MODEL: Karma Revero**DATE:** February 2018**First Release****TITLE:** Steer Column Telescope Actuator Nut, Bolt Torque Increase**PRIORITY:** On Complaint**APPLICABILITY:** MY17 and MY18 Revero**MARKET REGION:** North America**PURPOSE:** Remedy a “Lash” or “Knocking Noise” when pulling and pushing the steering wheel in and out of dash.

Technical Service Bulletin

TB-18-44-01

fig. 2

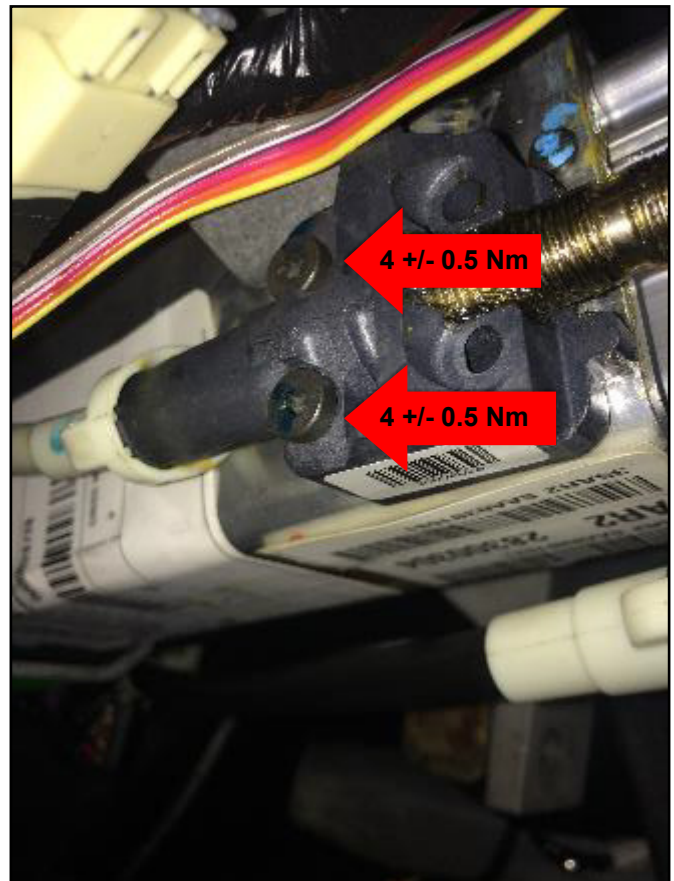
A clunking noise can be heard and felt when pushing and pulling the steering wheel into the dash. The steering wheel can feel “loose.” Sound comes from steering column.

The knee bolster will need to be removed to access the bolts. Follow the service manual procedure if required. two bolts will be reveal as indicate (fig. 1).

Verify the exposed bolts torque.

Use a torque wrench capable of measuring 4 Nm,

Using a T25 Torx bit, tighten bolts to the specified torque.

The specified torque is 4 +/- 0.5Nm (fig. 2)
